ONS-2015-052

**Subject:** Response to Request for Additional Information dated March 27, 2015, Related to the Oconee Expedited Seismic Evaluation Process (ESEP) Report

**Oconee Nuclear Station Units 1, 2, and 3  
Duke Energy Response to Questions from NRC E-mail dated  
March 27, 2015, Related to the Oconee  
Expedited Seismic Evaluation Process (ESEP) Report**

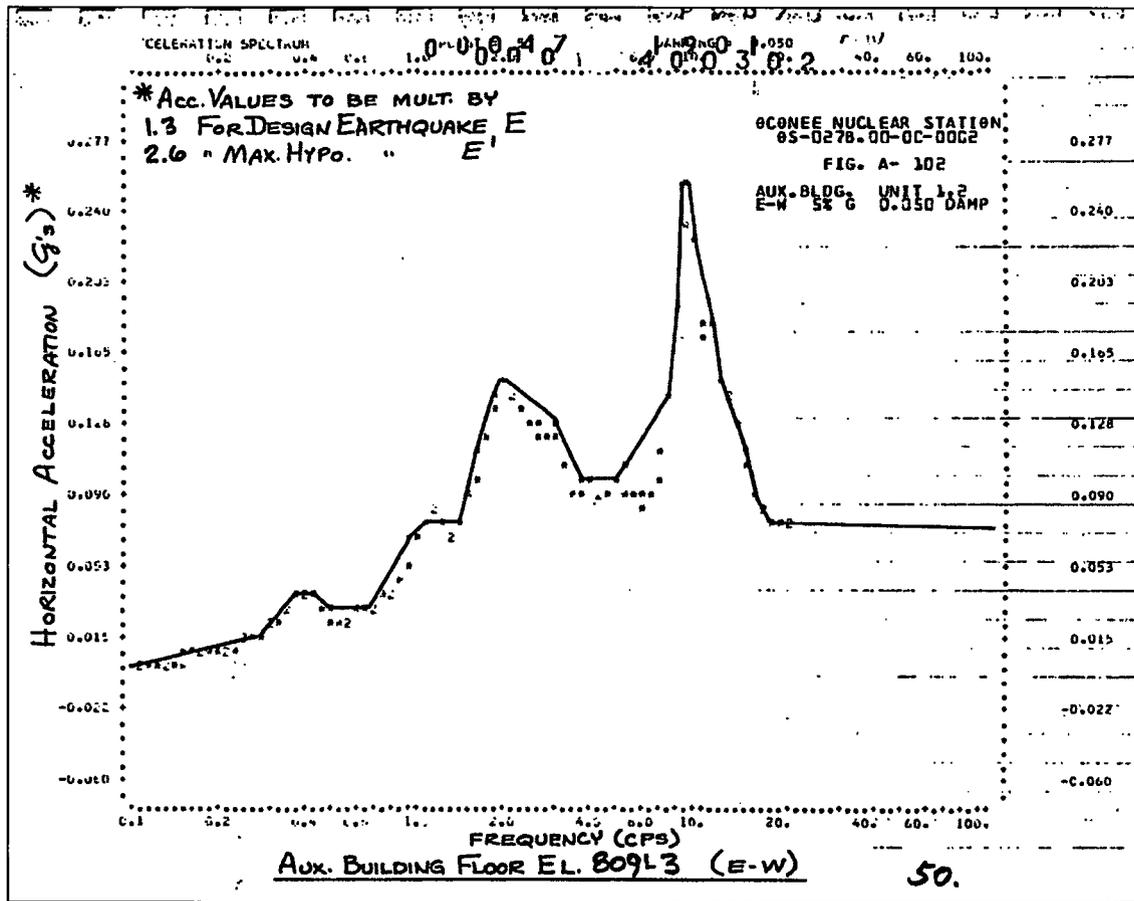
Please clarify how raw ISRS and peak clipping were used in the screening process, and provide the technical basis. Additionally, provide the range of calculated clipping factors, the reference for the equation used, and an example showing representative raw ISRS and the corresponding clipped ISRS.

ONS design-basis ISRS are given in OSS-027B.00-00-0002, Revision 8, “Specification for the Seismic Displacements and Response Spectra for the Turbine, Auxiliary, Reactor and Standby Shutdown Facility Buildings.” An example spectrum, typical of each building other than the SSF, is given below. The spectrum is not a typical broadened ISRS, which is peak-broadened by +/-15%. The ISRS were considered to be raw, unbroadened spectra for the ESEP evaluation. The exception to this was ISRS in the SSF. The SSF ISRS were developed later than the original design-basis spectra. The SSF has both raw, unbroadened spectra and peak-broadened ISRS available. The ESEP evaluation used the raw, unbroadened spectra as per EPRI NP-6041-SL.

Peak clipping was performed only for use in screening against EPRI NP-6041-SL Table 2-4 or for comparison to test response spectra. Clipped-peak spectra were not used for anchorage evaluations. The technical basis for using clipped-peak spectra, for comparison to wide-band earthquake experience or test response spectra, is given in EPRI 1019200, Seismic Fragility Applications Guide Update. The ESEP peak clipping followed the methodology in Appendix Q of EPRI NP-6041-SL. The calculated clipping factors ranged between 0.55 and 1.0. If the calculated clipping factor would reduce the primary peak to less than an adjacent peak, the reduction was limited to the value of the second peak. None of the clipping factors were less than 0.55.

The following example shows the peak clipping for the ISRS for Elevation 809'-3" of the Unit 1-2 Auxiliary Building. The design-basis ISRS are from Figures A-102 and A-93 of OSS-027B.00-00-0002 for the East-West and North-South directions, respectively. The example also shows the averaging of the peak spectral accelerations, which is discussed in Question 2.

**Figure 4-5. ONS SSE (5% Damping)(Corrected).**

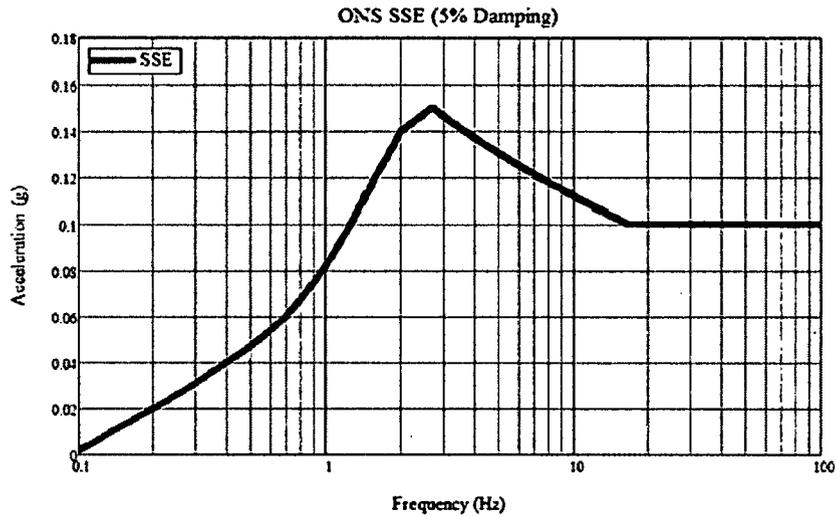
The graph in Figure 4-5 of the ESEP report is the incorrect illustration.  
The figure below is the correct graph.

*The purpose this graph had in the report was to illustrate a subset of data from another graph (also in the report). The figure in the original report had an incorrect graph line, which invalidated the illustration, but had no bearing on the technical validity of the report.*
